NINE MILE POINT NUCLEAR STATION, UNIT NO. 1

AMENDMENT TO FACILITY OPERATING LICENSE

Amendment No. 41  
License No. DPR-63

ATTACHMENT TO LICENSE AMENDMENT NO. 41

Figure 3.1.7a Maximum Allowable Average Planar LHGR Applicable to 8DB250 Fuel as described in Reference 8

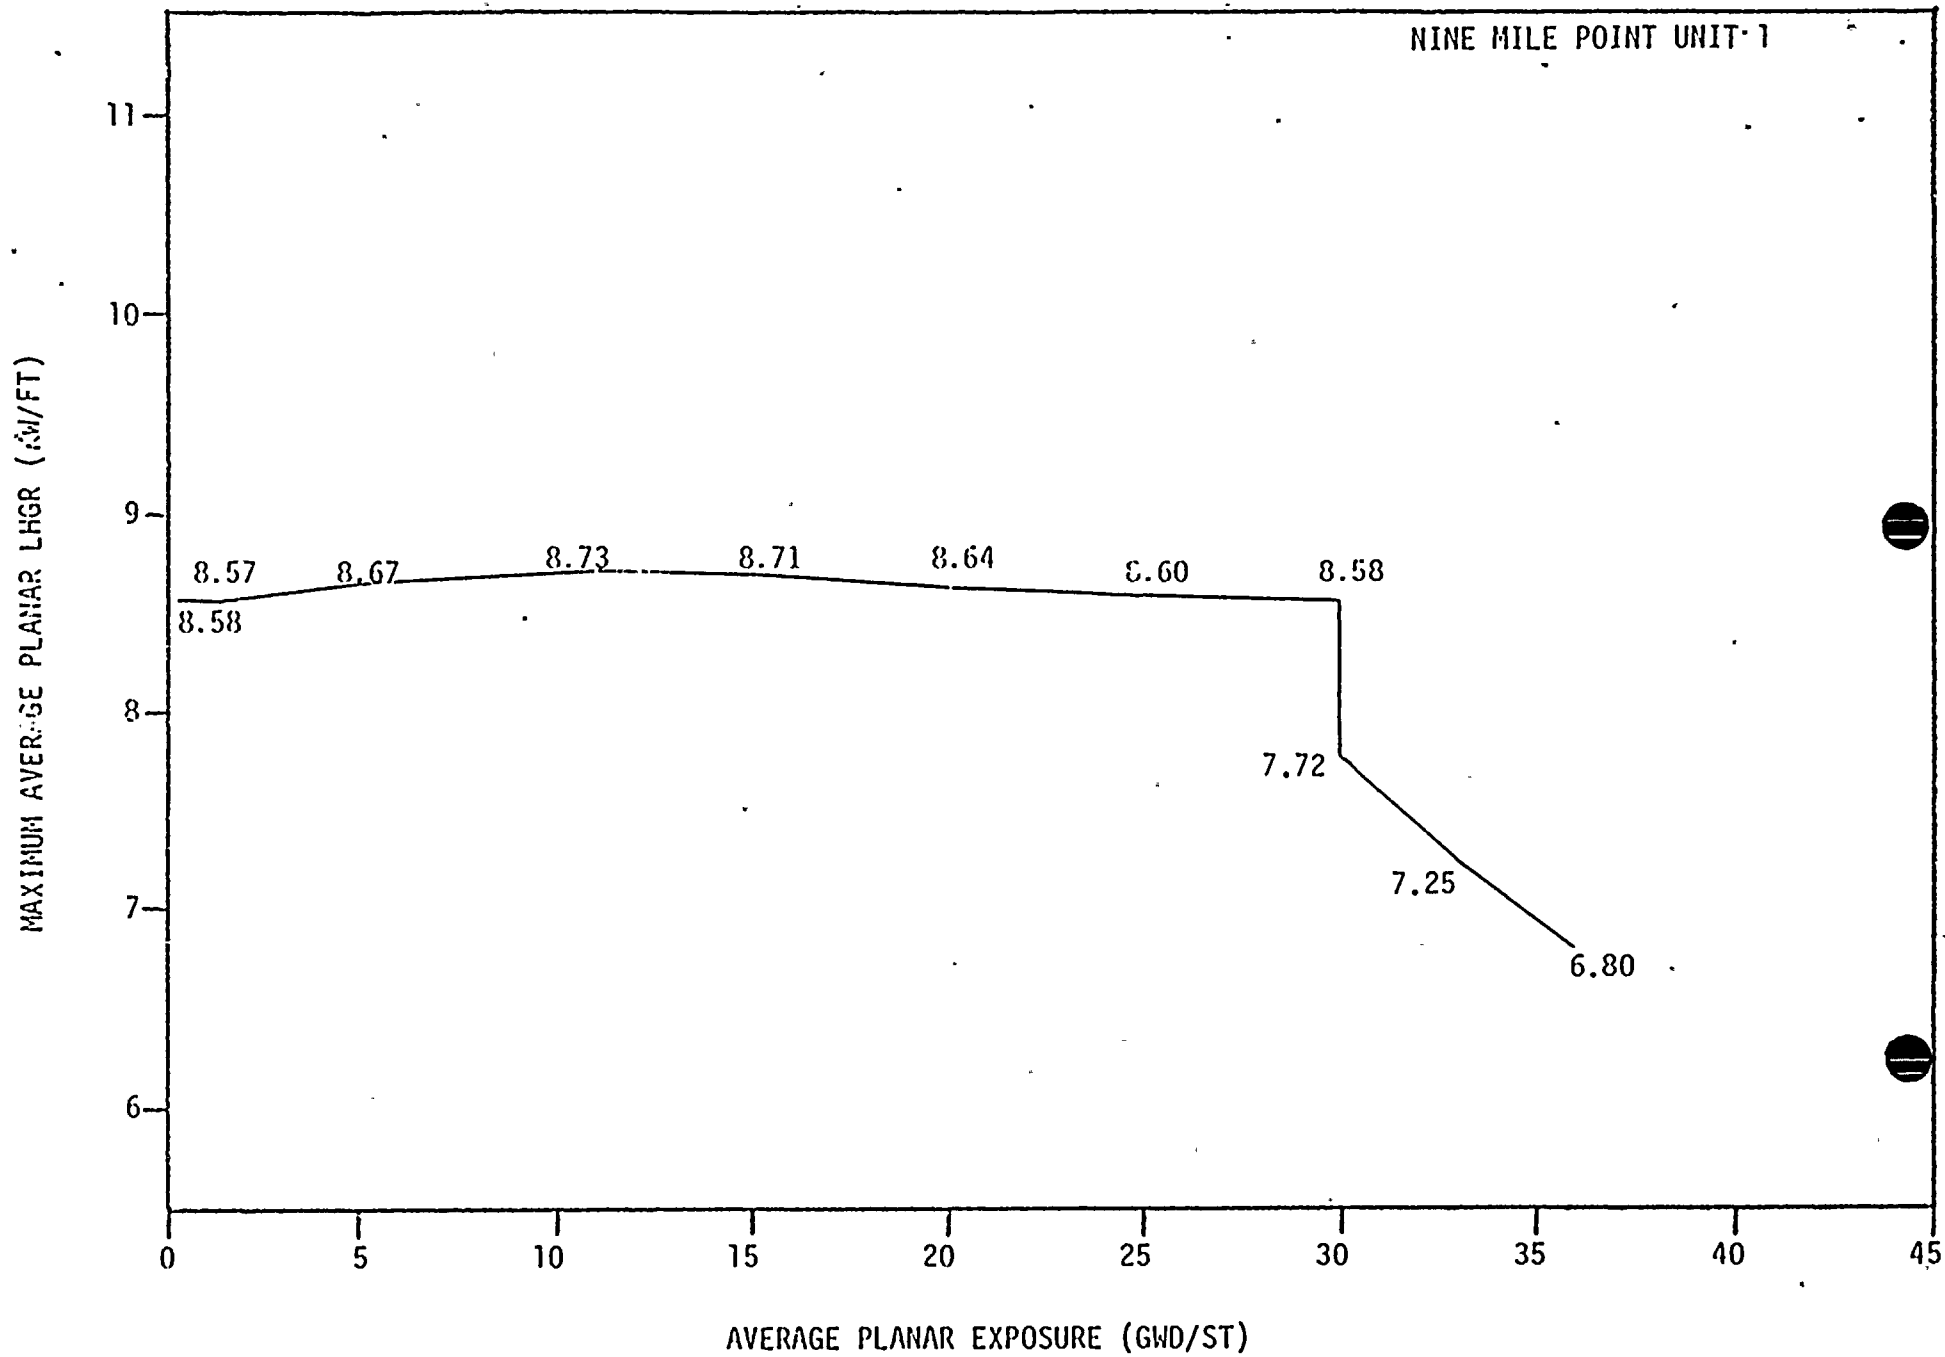
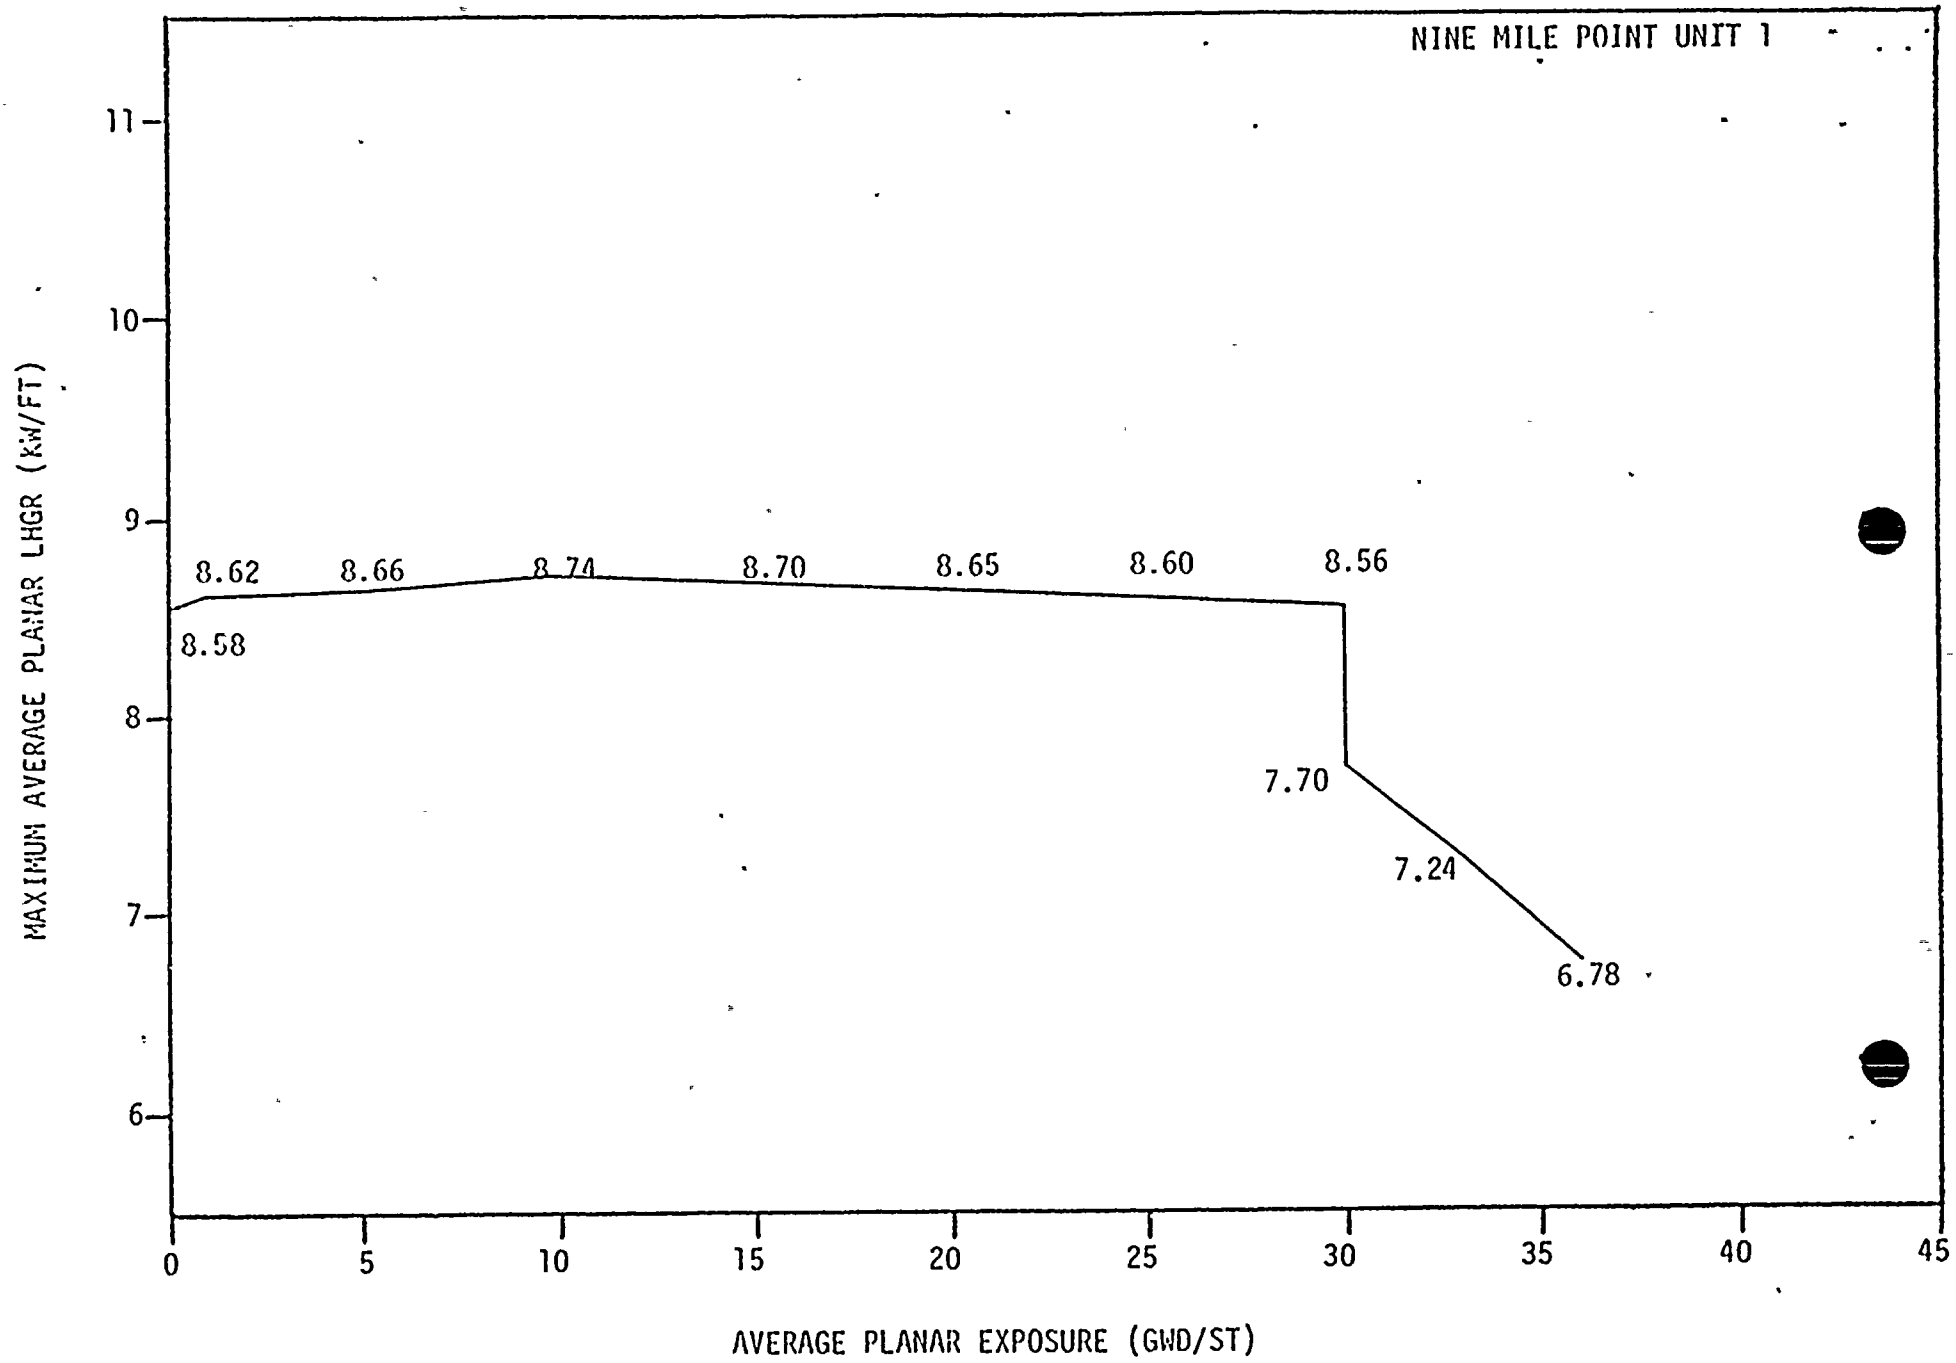
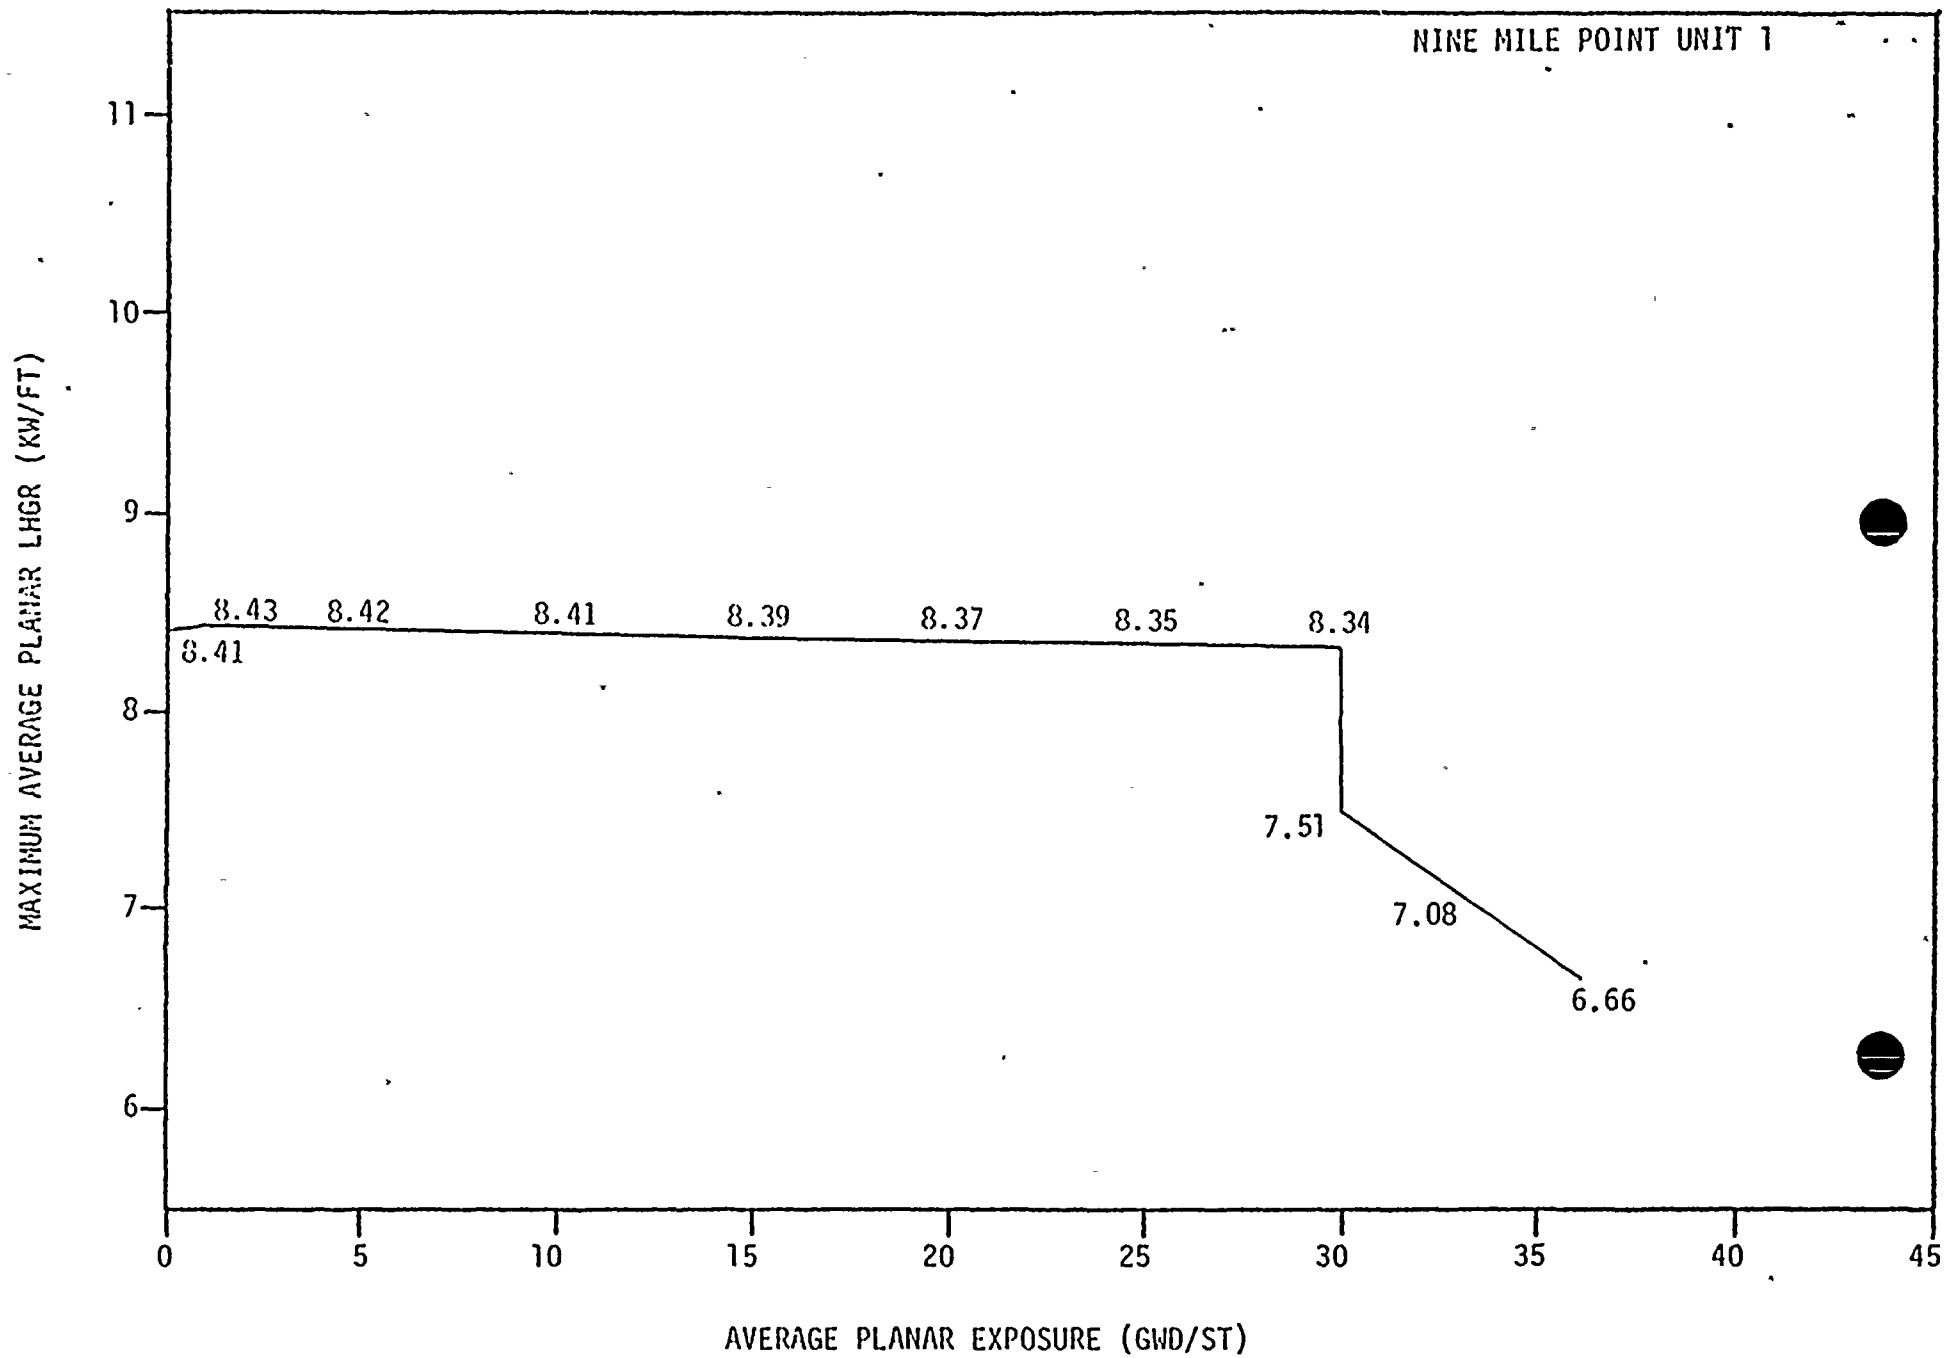
During power operation, the APLHGR for each type of fuel as a function of average planar exposure shall not exceed the limiting value shown in Figures 3.1.7a, 3.1.7b, 3.1.7c, 3.1.7d and 3.1.7e. If at any time during power operation it is determined by normal surveillance that the limiting value for APLHGR is being exceeded at any node in the core, action shall be initiated within 15 minutes to restore operation to within the prescribed limits. If the APLHGR at all nodes in the core is not returned to within the prescribed limits within two (2) hours, reactor power reductions shall be initiated at a rate not less than 10% per hour until APLHGR at all nodes is within the prescribed limits.
